Access Compliance Report

Public Rights-of-Way

Intersection ID: N/A	Main Street: BLYTHNE_BV	Cross Street: N/A	Location: NE
ADA ID: 59AEF6421D57	Ramp Type: Perp	Initial Pass/Fail: Fail	Overall Compliance: No
Severity Score: 22.5			
Codes/Mitigation Info/Possible Solution		Field Measurements/Component Compliance

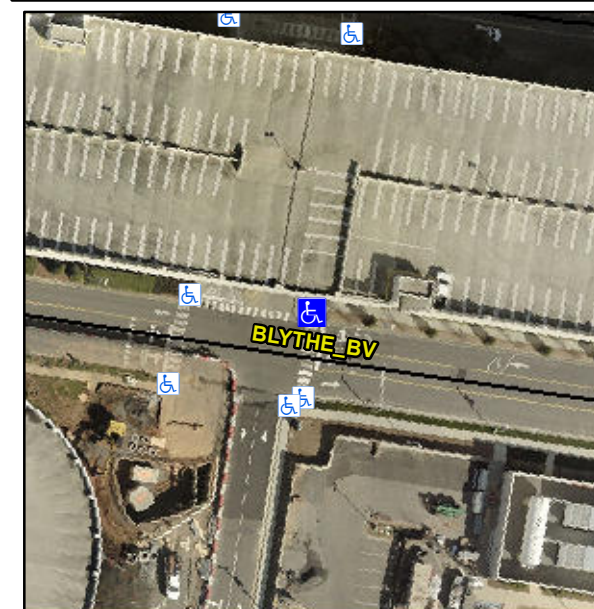
Not Found, R304.5.1, R304.2.2, R304.5.3

Compliance	Description	Data	Compliance	Description	Data
N/A	Ramp Length (in)	78.0	No	Ramp Slope (%)	8.9
No	Ramp Width (in)	47.5	No	Ramp XSlope (%)	4.1
N/A	Flare Type LT	N/A	N/A	Flare Type RT	N/A
N/A	Flare Slope LT (%)	N/A	N/A	Flare Slope RT (%)	N/A
N/A	Flare Traversable LT?	N/A	N/A	Flare Traversable RT?	N/A
N/A	Landing Length (in)	N/A	N/A	DWS Provided?	N/A
N/A	Landing Width (in)	N/A	N/A	DWS Contrast?	N/A
N/A	Landing Slope (%)	N/A	N/A	DWS Length (in)	N/A
N/A	Landing X Slope (%)	N/A	N/A	DWS Full Width?	N/A
N/A	Landing Curb? (Y/N)	N/A	N/A	DWS Offset (in)	N/A
N/A	Shared Landing?	N/A			
N/A	Gutter Ponding?	N/A	N/A	Gutter Slope (%)	N/A
N/A	Gutter Lip Ht (in)	N/A	N/A	Gutter X Slope (%)	N/A
N/A	Painted X Walk1?	Yes	N/A	Painted X Walk2?	N/A
	X Walk 1 Direction	To SW		X Walk 2 Direction	N/A
N/A	X Walk 1 Width (in)	74.0	N/A	X Walk 2 Width (in)	N/A
	X Walk 1 Slope (%)	11.5		X Walk 2 Slope (%)	N/A
	X Walk 1 X Slope (%)	2.0		X Walk 2 X Slope (%)	N/A

Remove & Replace Entire Ramp.
